PRODUCT SUPPORT BULLETIN BULLETIN NO. 298

MACHINE: **Model 99C Spike Driver**

SUBJECT: **Float Switch Failures – Part No. 5194901**

Figure 2

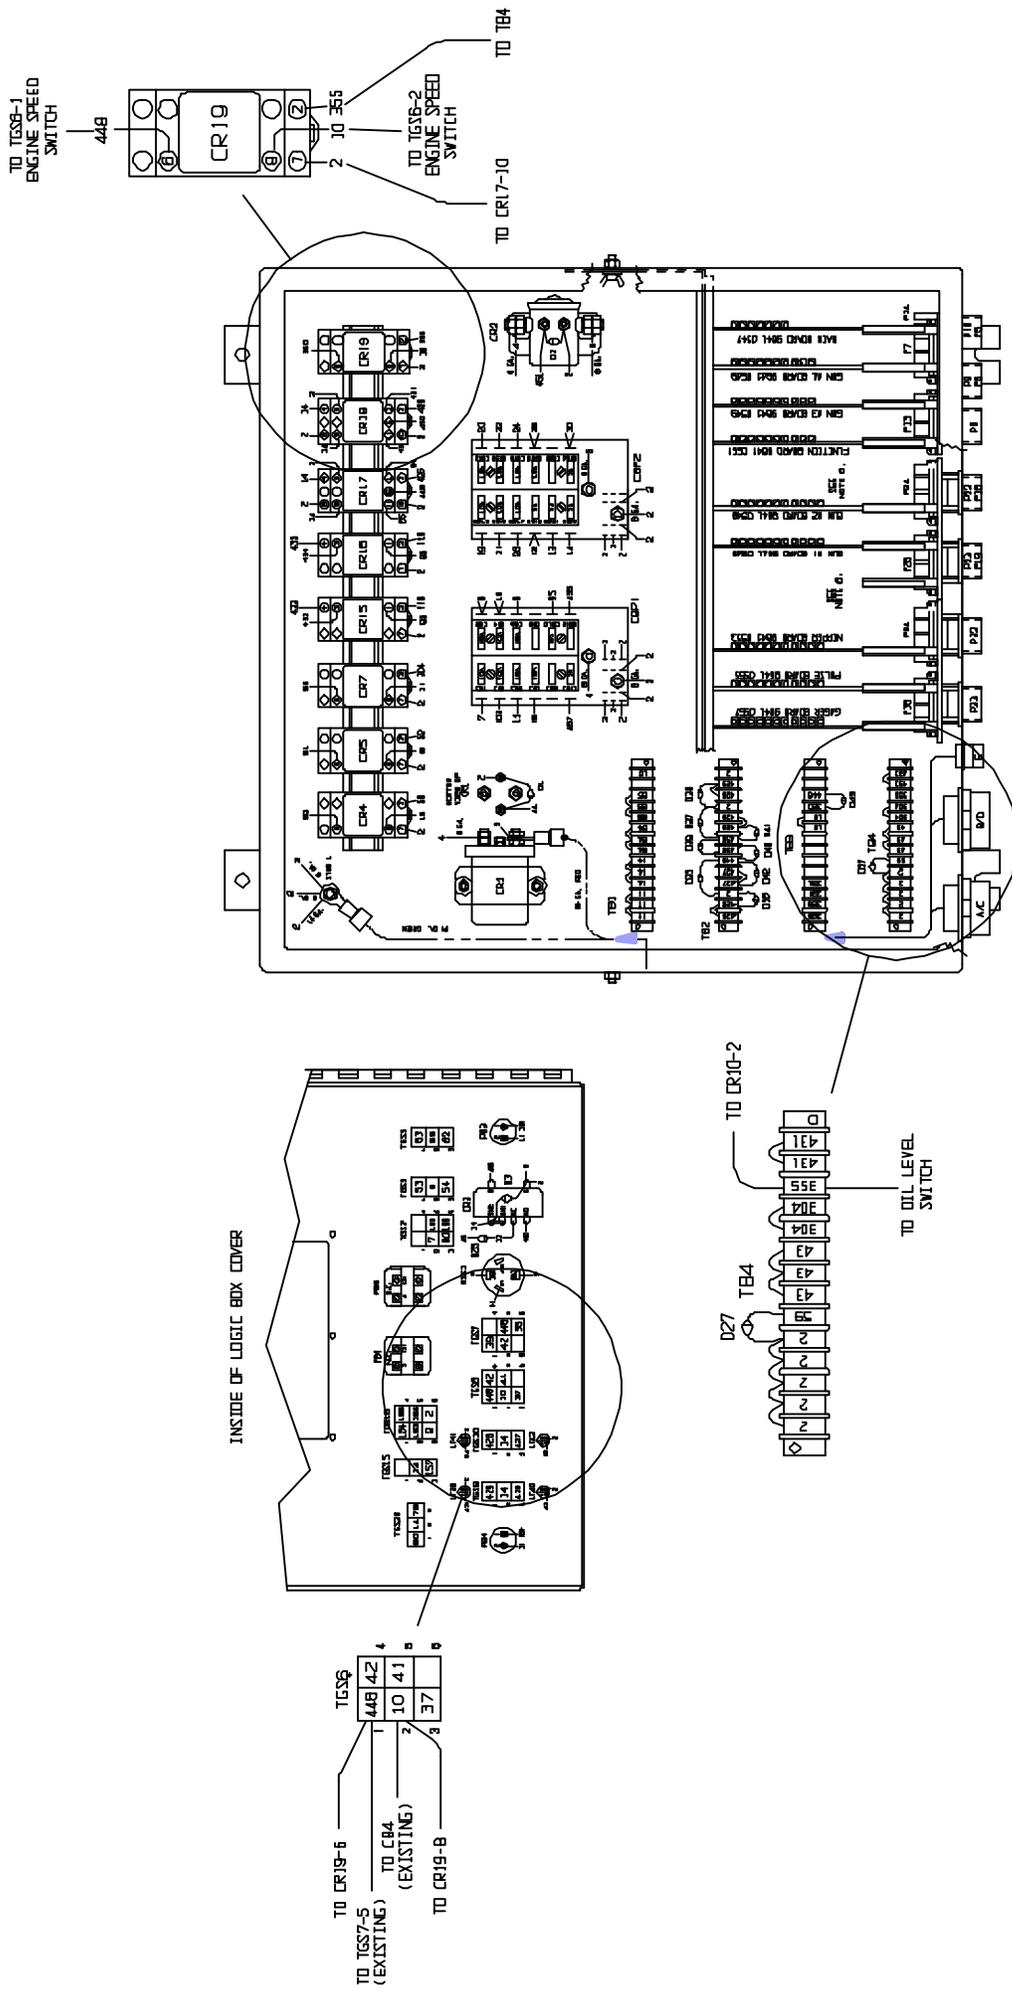
1. Water entering the switch through the wiring at the top of the switch. This problem is being addressed by the addition of a weatherproof elbow and cord seal at the top of the switch. The elbow will prevent water from running down the wires into the switch.
2. Electrical failure due to more current draw than the rated capacity for the switch. A relay is being installed in the pump destroke valve circuit to reduce the electrical load seen by the switch. The relay snaps into the existing mounting track inside the Main Logic Box and wired as shown in Figure 2.

Any failed Float Switches will be replaced under warranty. In addition **Relay Kit, part number 98410052** containing a **relay, part number 5196101; Relay Socket, 5155281;** and **Relay Hold Down Clip, 75060218,** will be supplied under warranty for machines with serial numbers up to and including s/n410242. To receive warranty replacement of a switch or relay, telephone the NORDCO Service Department toll free at 1-800-445-9258. Please have the serial number for the machine available. Warranty requests without the machine serial number cannot be honored.
